UN/SCETDG/49/INF.4/Add.1 UN/SCEGHS/31/INF.3/Add.1

**Issues relating to the Globally Harmonized System
of Classification and Labelling of Chemicals: Use
of the Manual of Tests and Criteria in the context
of the GHS**

Revision of the Manual of Tests and Criteria: Part I : Chapters 10 to 17

**Transmitted by the Chairman of the Working Group on Explosives on
behalf of the Working Group**

Figure 15.4.1.1: CAP SENSITIVITY TEST (using steel witness plate)

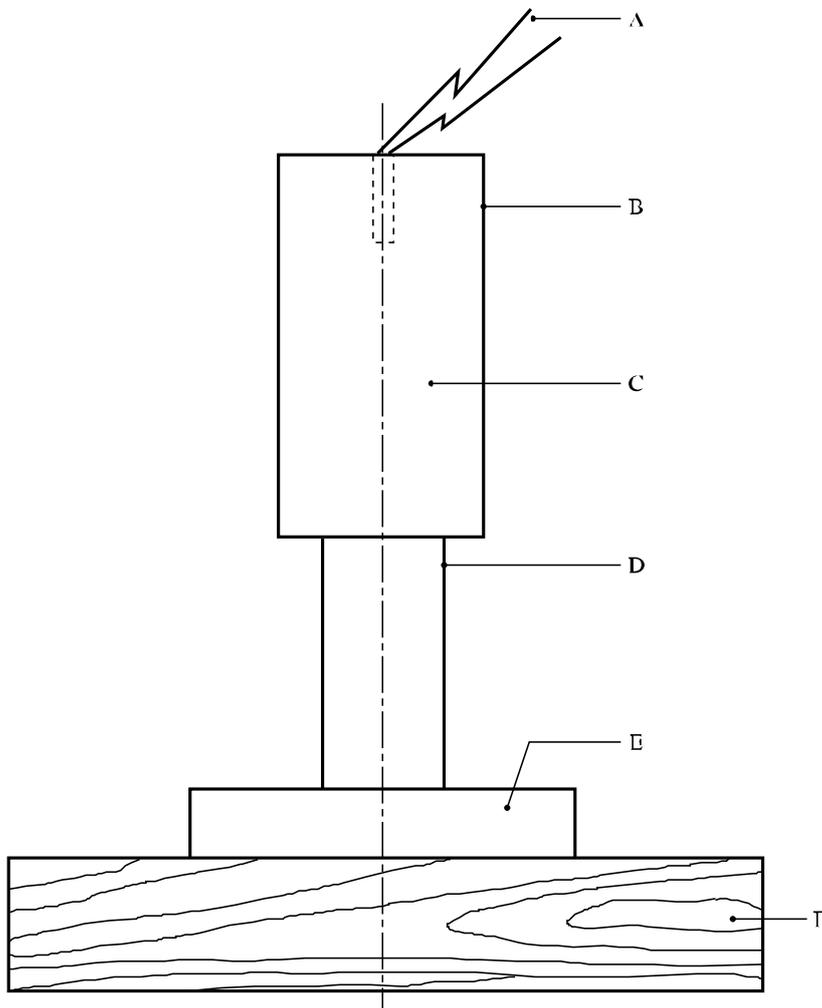
Comment [Ed12]: 15.4.1.2 only refer to a cardboard tube
